Altis Warehouse and Logistics Hub

*State Significant
Development
Modification Assessment
(SSD 7173 MOD 3)*

December 2018

Figure 4 | Approved Subdivision Plan with Proposed Modifications

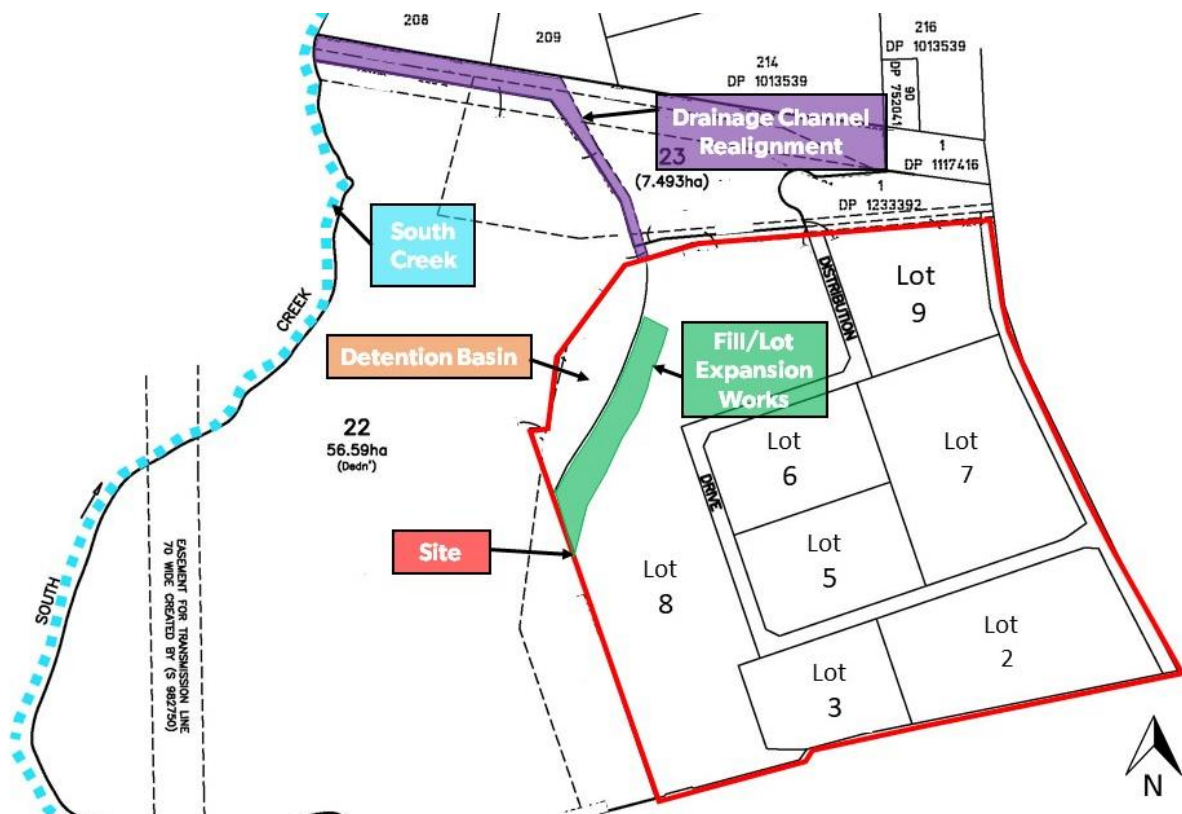
The modification application seeks to import approximately 34,000 m³ of additional fill material to fill and level the north-western portion of approved lot 8 as shown in **Figure 4**. The fill material is proposed to be Virgin Excavated Natural Material (VENM) which meets the requirements of the NSW Environment Protection Authority's (EPA) Excavated Natural Material Order 2014 and the *Protection of the Environment Operations (Waste) Regulation 2014* in accordance with the approved Fill Importation Protocol (FIP) for the site.

The Department notes the Applicant's modification request refers to fill works as "Lot 5 Expansion Works". However, in accordance with the approved subdivision plan, the proposed fill works are located at lot 8 and will be referred to as such throughout this report.

Figure 5 | Approved and Proposed Drainage Works

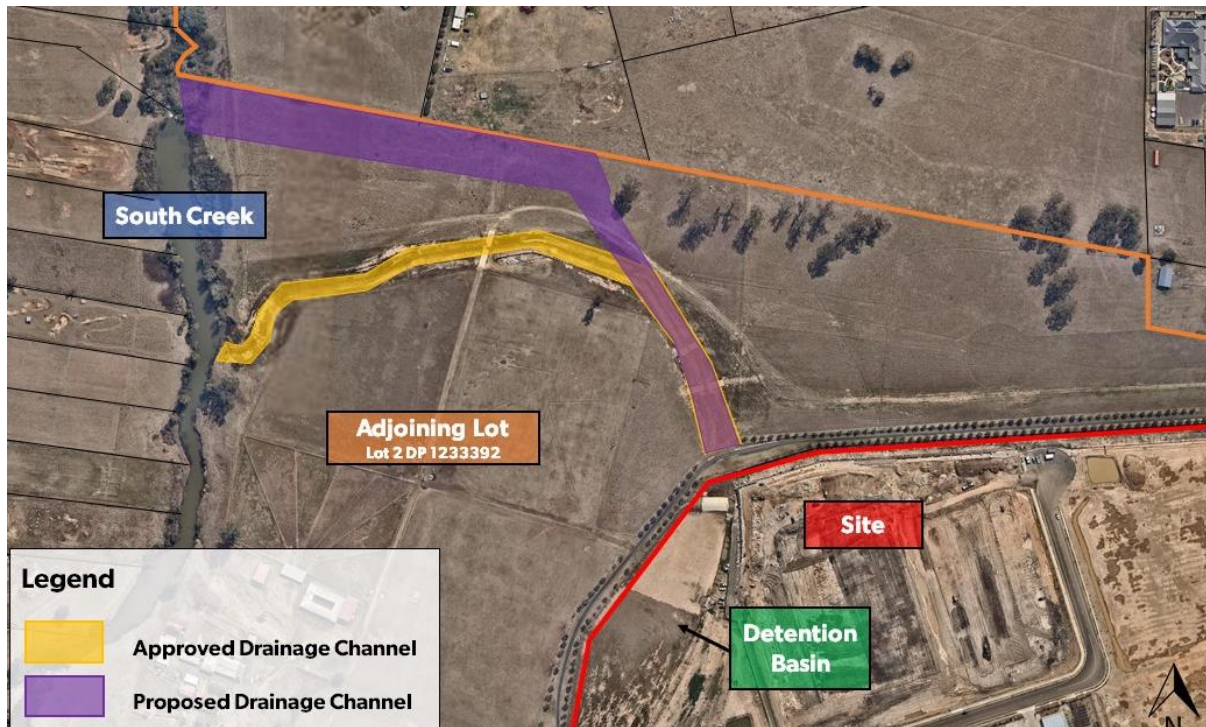
The modification application seeks to realign the approved drainage channel (shown on **Figures 3 and 5**) to extend up to and parallel to the northern boundary of Lot 2 DP 1233392, as depicted in purple on **Figures 4 and 5**. The proposed channel is 35 m wide.

The approved drainage channel has already been constructed but would be decommissioned and filled to the pre-existing levels. The filled area would be depressed slightly to act as an overland flow path.

The Applicant is seeking the proposed drainage channel realignment to enable better use of the farming land at Lot 2 DP 1233392. The Applicant has advised this was included as a condition of sale of that land between the previous landowner and the Applicant. The Applicant has further stated these works would also improve the local stormwater runoff to South Creek.
